**LEVY NUCLEAR PLANT, UNITS 1 AND 2
DOCKET NOS. 52-029 AND 52-030
RESPONSE TO REQUEST FOR ADDITIONAL INFORMATION LETTER NO. 091 RELATED TO
GROUNDWATER**

**Levy Nuclear Plant Units 1 and 2
Response to NRC Request for Additional Information Letter No. 091 Related to
SRP Section 2.4.12 for the Combined License Application, dated May 7, 2010**

Attachment 02.04.12-22A

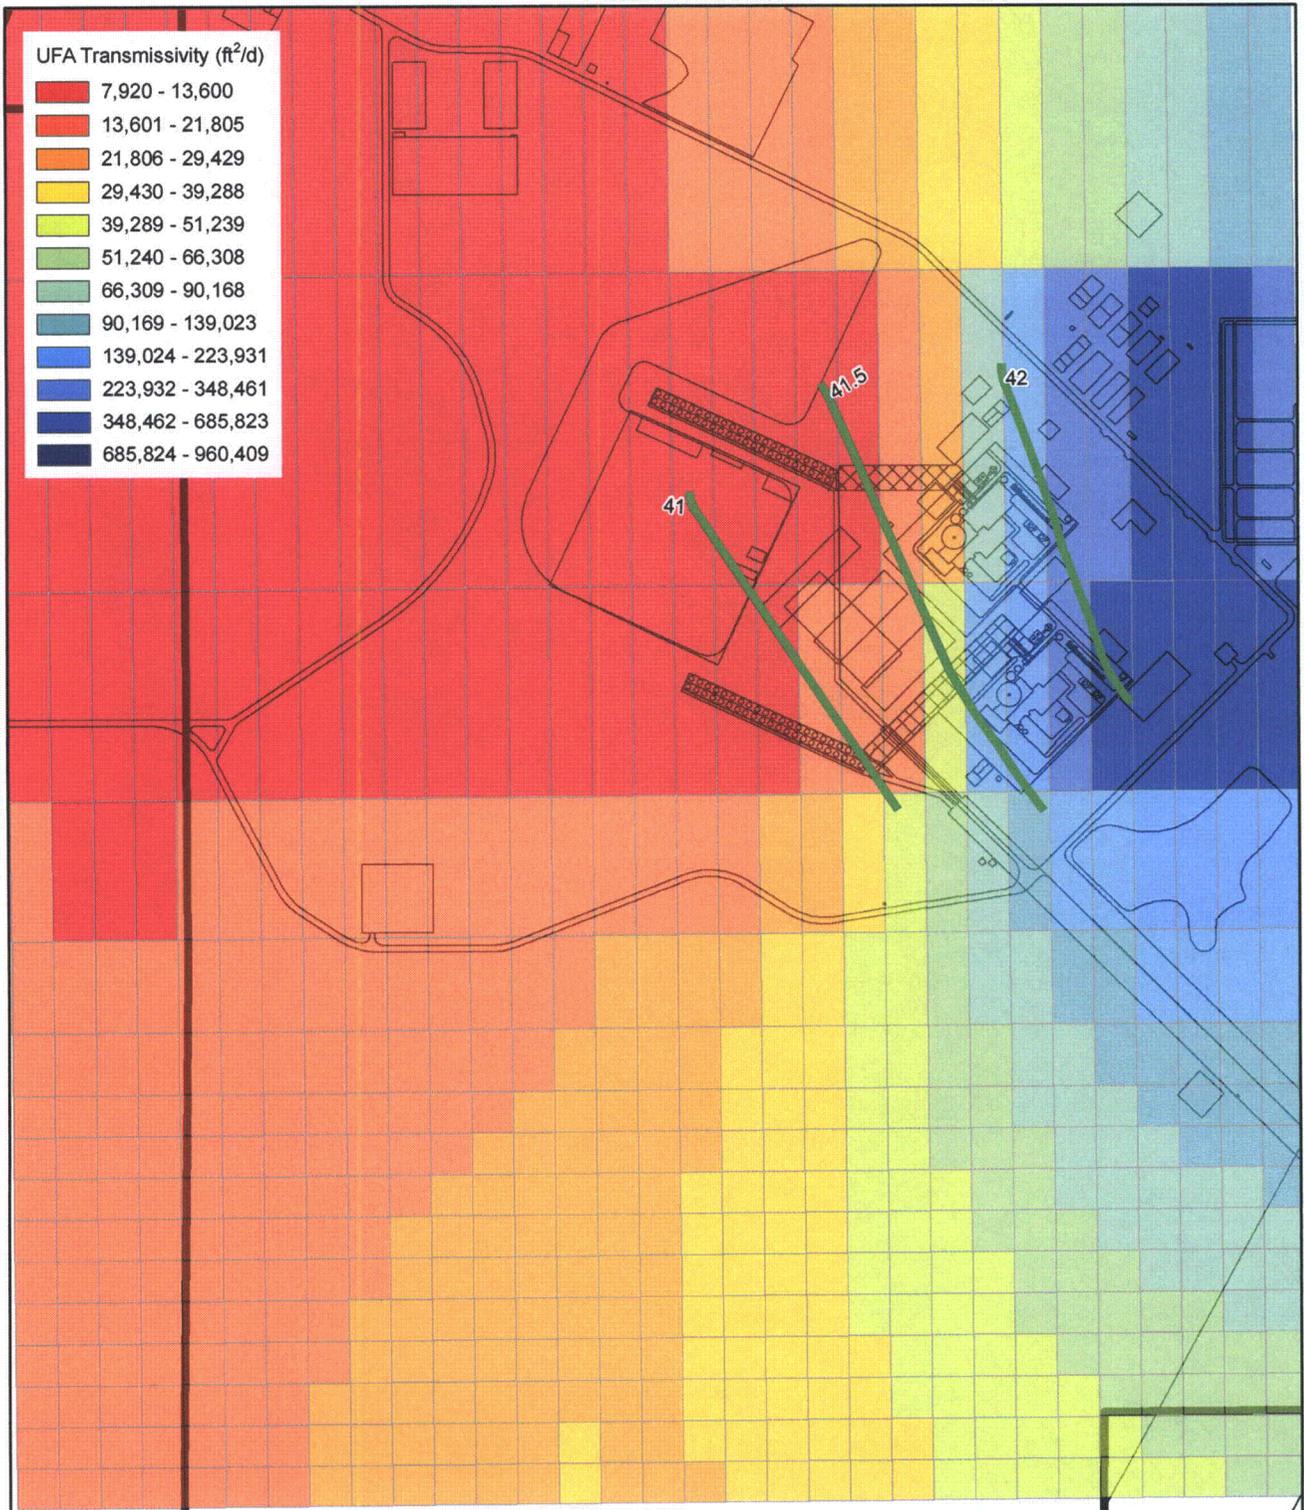
The transmissivity of the upper Floridan aquifer estimated from pumping test responses of wells in the vicinity of LNP Units 1 and 2 ranged from 4000 to 53,000 ft²/d (PEF 2009] ML0921509601L-0363 –RAI response letter NPD-NRC-2009-177). This is equivalent to a hydraulic conductivity range of 16 to 212 ft/d assuming an aquifer thickness of 250 ft. The map in Figure 10 of the revised DWRM2 groundwater flow model (338884-TMEM-123) shows an upper Floridan aquifer transmissivity range of 7920 to 50,000 ft²/d from model calibration over the flow path between the hypothetical release site and the receptor locations. Provide a discussion of how the calculated seepage velocity reported in FSAR Table 2.4.12-212 and RAI supplemental response NPD-NRC-2009-177, which is based on a horizontal hydraulic conductivity of 54.4 ft/d, represents a conservative estimate or justify its exclusion.

The direction of groundwater flow in the Upper Floridan aquifer at the LNP site is generally west-southwest. Attachment 02.04.12-22A presents a larger scale (i.e., "zoomed-in") version of Figure 10 from LNP ER RAI 05.02.02-04, Attachment 05.02.02-04A (338884-TMEM-123, "Revised Groundwater Model Evaluation of Simulated Drawdown Water Impacts, Levy Nuclear Plant, Rev 0"), to clarify the DWRM2 transmissivity values near the LNP site in the direction of groundwater flow. As shown on Attachment 02.04.12-22A, the transmissivity of the Upper Floridan aquifer simulated by the revised DWRM2 model between LNP 1/LNP 2 and the property boundary in the direction of groundwater flow is primarily between 7,920 and 29,429 ft²/day.
